APPLICATION NO.	FILING DATE	FIRST NAMED INVENTOR	ATTORNEY DOCKET NO.	CONFIRMATION NO.
10/085,413	02/28/2002	Brian Tse Deng	TI33539	3213
23494	7590	05/01/2006	EXAMINER	
TEXAS INSTRUMENTS INCORPORATED			DANG, KHANH	
P O BOX 655474, M/S 3999			ART UNIT	
DALLAS, TX 75265			PAPER NUMBER	
			2111

Office Action Summary	Application No. 10/085,413	Applicant(s) DENG ET AL.	
	Examiner Khanh Dang	Art Unit 2111

DETAILED ACTION

(see National Semiconductor, CD4015.)

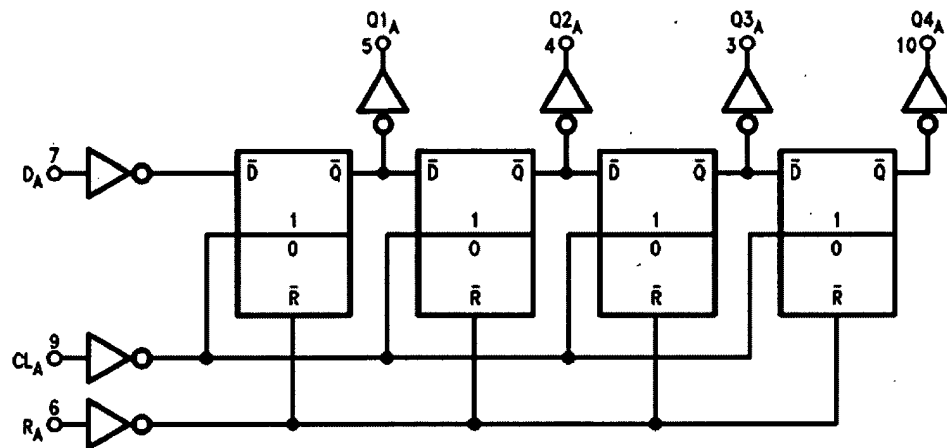
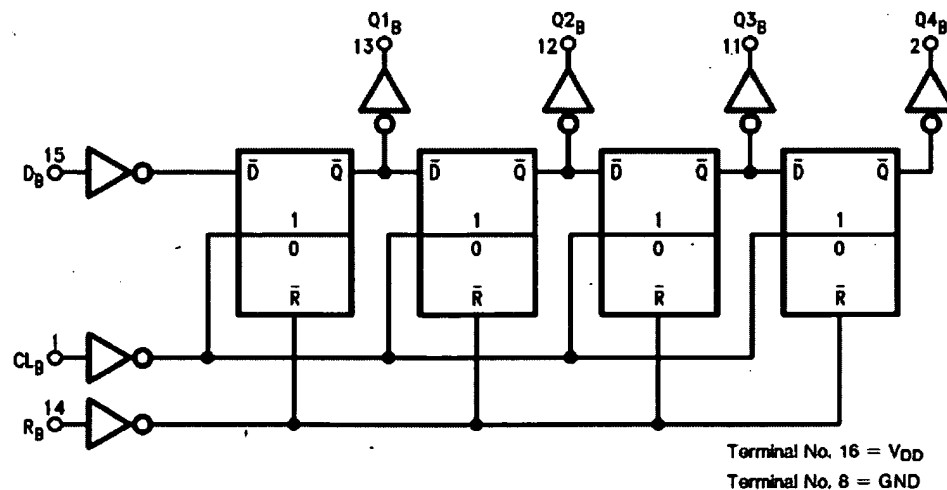
With regard to claim 10, Norris discloses a signal debouncing circuit (shown generally at Figs. 1 and 2; the shift register 14 of the debouncing circuit of Norris is a CD 4015 serial in-parallel out shift register. A serial in-parallel out shift register is shown below (see Wikipedia definition of a shift register, cited below):

Specifically, the CD 4015 shift register of Norris is show below:

comprising: a memory device (it is clear from above that the first flip flop of the shift register 14 is readable as a memory device) coupled to a signal line, the memory device to store a value based on a signal value on the signal line (the first flip-flop of the shift register 14 stores a value based on a signal value on the signal line from the switch 12 for storing an input value); a serially connected sequence of storage devices coupled to the memory device (a series subsequent flip flops is readable as a sequence of storage devices connected to the first flip-flop), wherein: an input of a first storage device is coupled to the memory device (the flip-flop adjacent to the first flip flop is readable as a first storage device coupled to the first flip-flop); an input of subsequent storage devices is selectively coupled to an output of a previous storage device (the input of the subsequent flip-flop is selectively coupled to the output of the previous flip-flop); and an output of a last storage device provides a debounced version of the signal value provided to the memory device (it is clear from above that the last flip-flop of the shift register 14 of the debouncing circuit comprises an output to provide a debounced signal originated from the signal value provided to the first flip-flop or "memory device" of the shift register 14 of the debouncing circuit of Norris).

With regard to claim 11, it is clear that the input of subsequent storage devices or subsequent flip-flops are selectively coupled to the output of a storage device immediately before it in the sequence of storage devices (note that the sequence of storage devices are the sequence of flip-flops between the first flip-flop and the last flip-
